**Planning Commission Regular Meeting**

Tuesday, August 18, 2026, 5:30 PM

The Mamba Trust Site  
Work Variance Request,  
219 Glen Eagle Loop

### **Planning Commission Staff Report**

## SITE PLAN

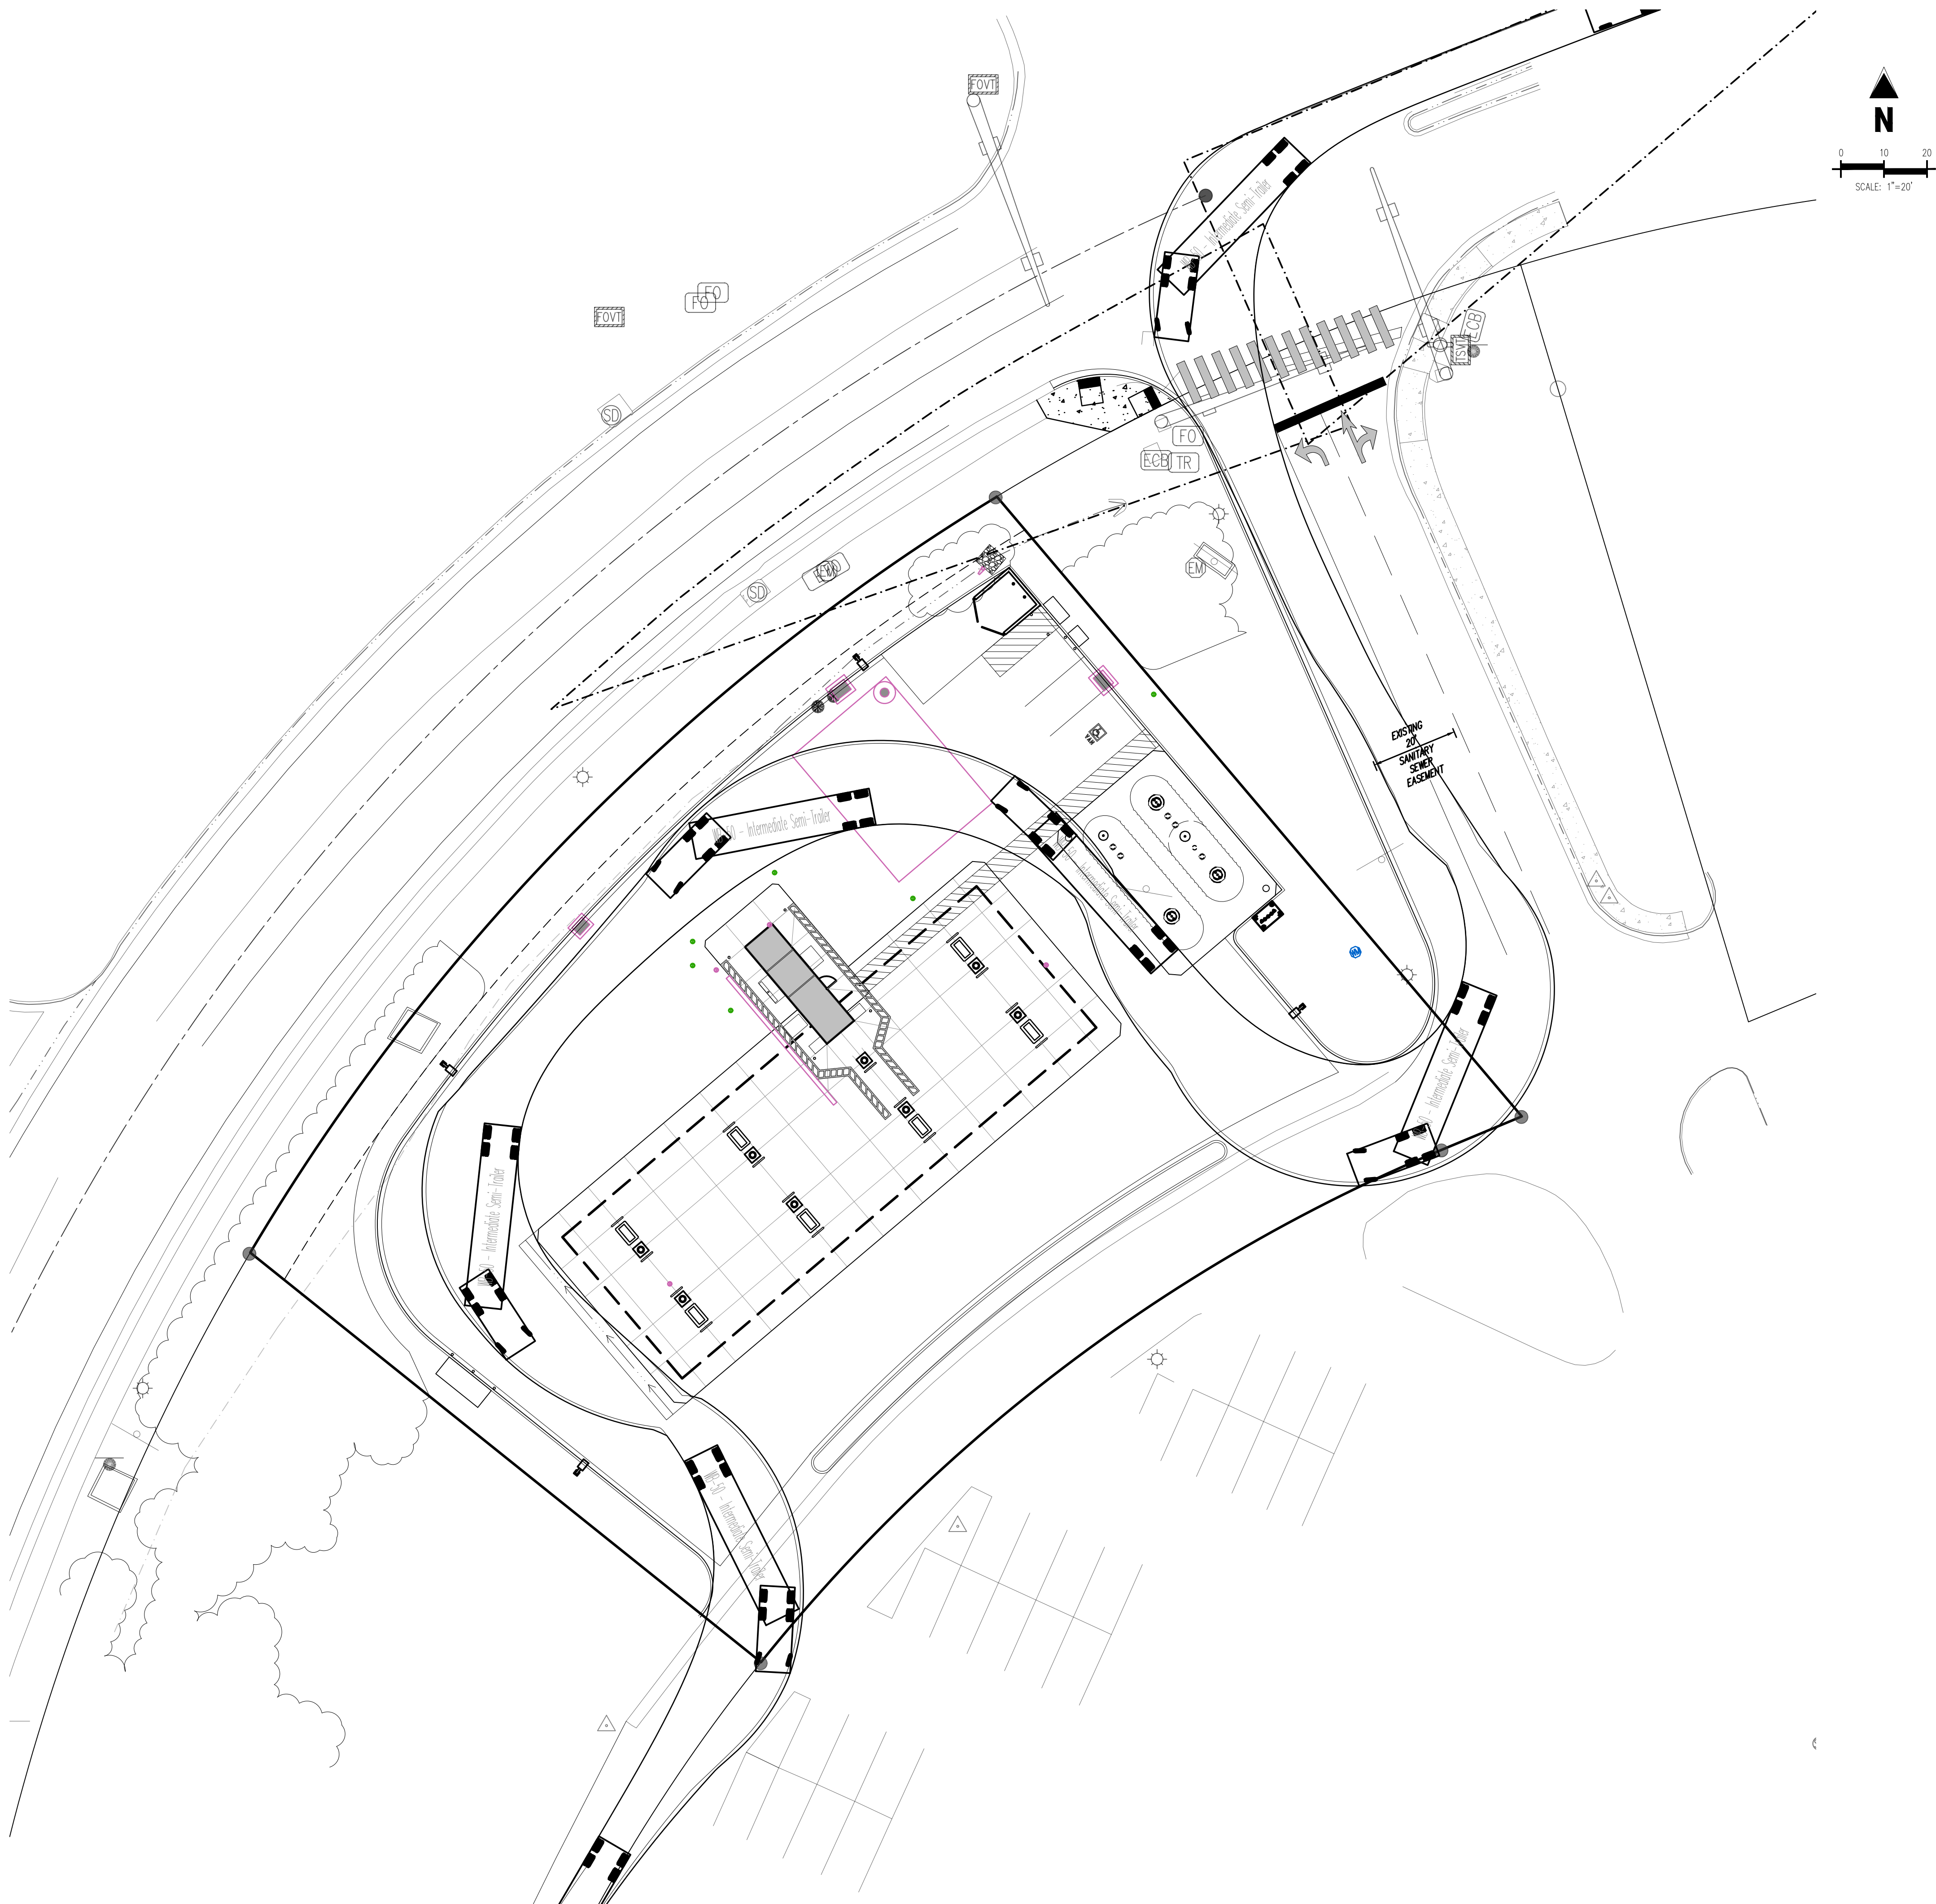
**Placement of Structures (9/A & 9/R):** Policy 9 requires a minimum 1-foot setback for commercial and other nonresidential structures. The site plan shows that the proposed structures maintain more than the minimum setback from all property lines.

Staff has repeatedly advised the applicant that future widening of North Park Avenue may require an additional northbound lane and could affect the property frontage. The current plan should not preclude that future improvement or place required landscaping, utilities, signs, or other critical improvements where they may need to be removed. Prior to the final hearing, the applicant shall coordinate with Town Engineering and CDOT to identify the future roadway envelope that should be accommodated and provide a dimensioned exhibit showing how the canopy, kiosk, tanks, detention, utilities, landscaping, trash enclosure, and circulation would function if the road widening occurs.

The current plans do not identify snow-storage areas or provide calculations for the recommended and proposed snow-storage areas. Prior to the final hearing, the applicant must identify functional snow-storage locations and provide the applicable calculations.

**Storage (14/A & 14/R):** Policy 14 requires commercial storage areas, including materials and equipment, to be screened in an aesthetically compatible manner. The site plan identifies a propane stand, air stand, portable DEF dispenser, tank vents, electrical equipment, and other exterior operational features. Prior to the final hearing, the applicant shall provide a coordinated plan identifying the final size, location, and screening of these elements. Any exterior merchandise or product displays shall also be identified on the final plans.

**Refuse (15/A & 15/R):** The site plan shows a trash enclosure near the northern portion of the property. No enclosure elevations, dimensions, material details, gate configuration, recycling capacity, or collection turning information have been provided. The final plans will need to demonstrate an enclosed and screened refuse and recycling area that meets Town standards, is architecturally compatible with the kiosk and canopy, provides adequate recycling capacity, and can be serviced without impairing pedestrian or vehicle circulation. The design should be coordinated with the Town's Sustainable Materials Management staff.

1. Corrected and complete plan set. Correct the project address to 430 North Park Avenue and the sheet index/count, and add a complete project-data table identifying the site area, exact kiosk gross floor area and density, height, impervious and pervious areas, parking, qualifying open space, snow storage, and setbacks.

5. Future roadway and site-planning exhibit. Coordinate with Town Engineering and CDOT to identify the future North Park Avenue roadway envelope that should be accommodated and demonstrate how the canopy, kiosk, tanks, detention, utilities, landscaping, refuse enclosure, and circulation would function if widening occurs.

8. Snow-stacking plan. Identify all areas to be cleared of snow and provide functional snow-storage calculations and locations, coordinated with landscaping, drainage, sight distance, equipment access, and fuel operations.

11. Refuse and recycling. Provide enclosure elevations, dimensions, materials, gate details, trash and recycling capacity, and service access/turning information, coordinated with the Town's Sustainable Materials Management staff.
